FORM APPROVED  
OMB NO. 1004-0135  
Expires July 31, 2010**SUNDRY NOTICES AND REPORTS ON WELLS**  
*Do not use this form for proposals to drill or to re-enter an abandoned well. Use form 3160-3 (APD) for such proposals.***SUBMIT IN TRIPLICATE - Other instructions on reverse side.**

1. Type of Well <input checked="" type="checkbox"/> Oil Well <input type="checkbox"/> Gas Well <input type="checkbox"/> Other		8. Well Name and No. BENSON 3 FED 2
2. Name of Operator CHESAPEAKE OPERATING, INC. Contact: LINDA GOOD E-Mail: linda.good@chk.com		9. API Well No. 30-015-26260-00-S1
3a. Address OKLAHOMA CITY, OK 73154-0496	3b. Phone No. (include area code) Ph: 405-935-4275	10. Field and Pool, or Exploratory SHUGART
4. Location of Well (Footage, Sec., T., R., M., or Survey Description) Sec 3 T19S R30E NENE 330FNL 480FEL		11. County or Parish, and State EDDY COUNTY, NM

CHESAPEAKE, RESPECTFULLY, REQUESTS PERMISSION TO PLUG & ABANDON THIS WELL PER THE FOLLOWING P&A PROCEDURE:

BENSON 3 FEDERAL 2

# Workover Proposal

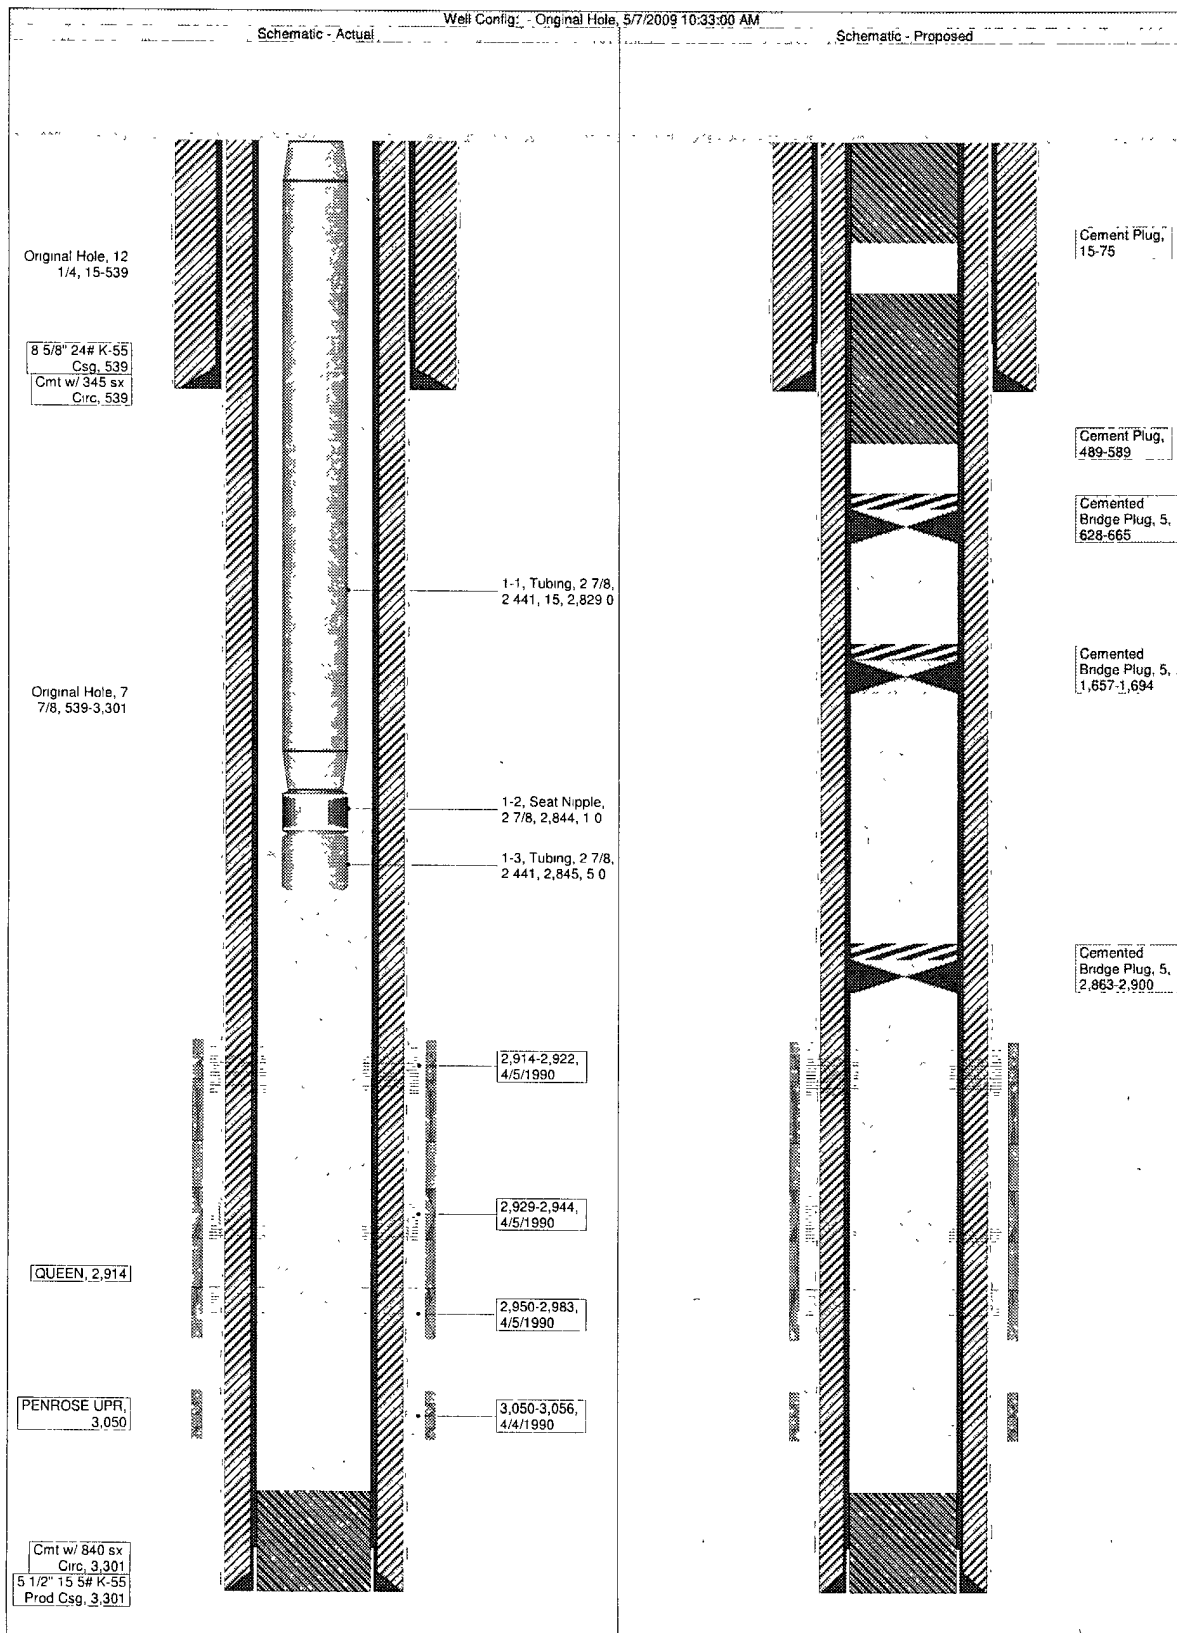
**\*\* BLM REVISED \*\* BLM REVISED \*\* BLM REVISED \*\* BLM REVISED \*\* BLM REVISED \*\***
